# United States Department of the Interior

May 21, 2021

The U.S. Fish and Wildlife Service (Service) has reviewed the Draft Permit for a Major Renewable Energy Facility, Docket Number 21-00026, dated March 15, 2021. The applicant, Heritage Wind, LLC, requests authorization from the New York State Office of Renewable Energy Siting (ORES) to construct and operate a wind energy project. The Heritage Wind project is located in the Town of Barre, Orleans County, New York.

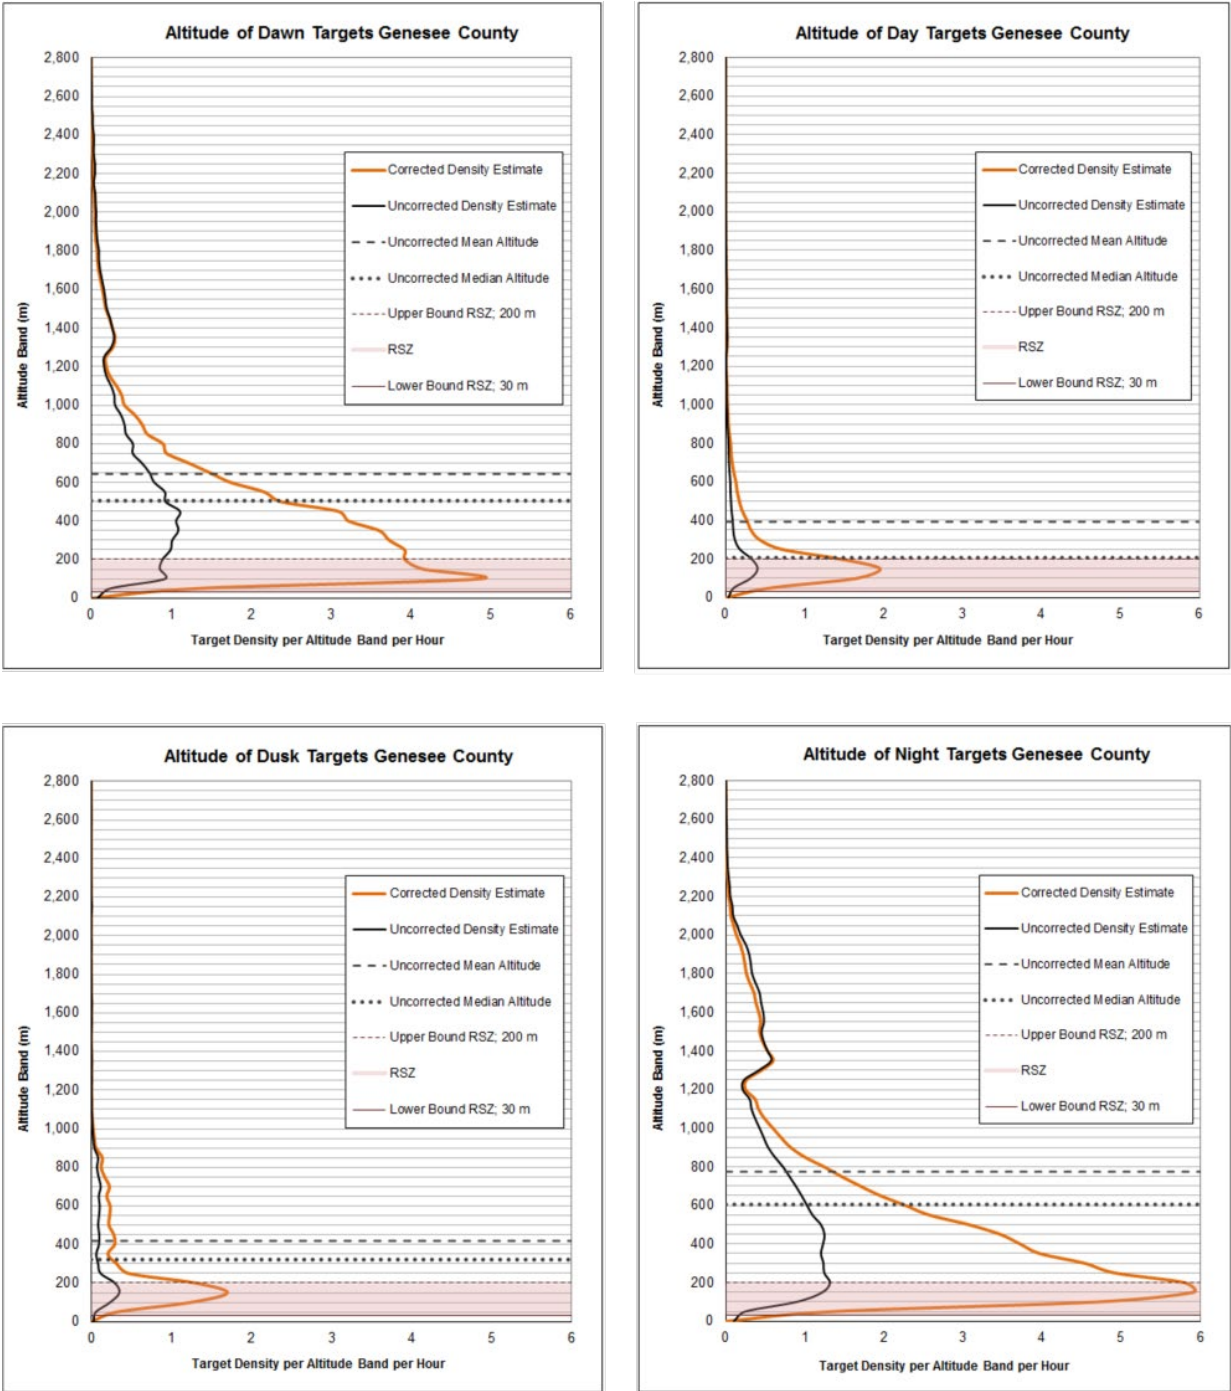
Migrant altitude was measured using vertical radar (a beam pointed straight up into the airspace). In general, migrant flight altitude was lowest at night at the inland site with a mean of 774 meters above ground compared to 992, 946 and 816m agl at the coastal sites. This data indicates that targets were lower to the ground when flying at night and peak target per hour densities were highest below 200 m which would fall within the rotor swept zone (see attached figure). Similarly, the altitude of migrants at dawn was lower than the other sites except one. Lower flight altitude, particularly at night, can increase target risk of collision. Further, if migrants are flying during inclement weather, poor visibility can increase risk and in some cases push migrants even lower altitudes and exasperate the risk.

Target density is another metric measured in this study. Using both horizontal and vertical data of migrants, the corrected density of the inland radar unit was much greater than the coastal station locations. This indicates that more targets were within the space of the rotor swept zone over the course of nocturnal migration also indicating potential higher collision risk.

The data indicated a pattern of dawn ascent to a greater degree than the coastal sites. This indicates that the habitat in and around the INWR provides valuable diurnal stopover habitat for migrants that rest and feed in the INWR and wildlife management areas after nocturnal flight. The study acknowledges this pattern and states these high levels of baseline activity may also indicate areas that could be at risk from renewable energy development. It is important to note that the data and analysis in this report considered smaller turbine heights and rotor swept zones than what is being proposed for the current project. Turbine blades which reach higher into the airspace and which cover much larger area during the rotation process are expected to increase the risk for collision. Therefore, given the data gathered, such as passage rate, direction of migration, target density within the rotor swept zone and the altitude of migrants in close proximity to the INWR and two state wildlife management areas, we view the proposed project site as an elevated risk to flying animals, especially the turbines closest to the important habitat. We consider the risk analysis completed for the project to be outdated and an unsubstantiated guess as to risk because it is based upon fewer and smaller turbine projects and does not consider site-specific flight data.
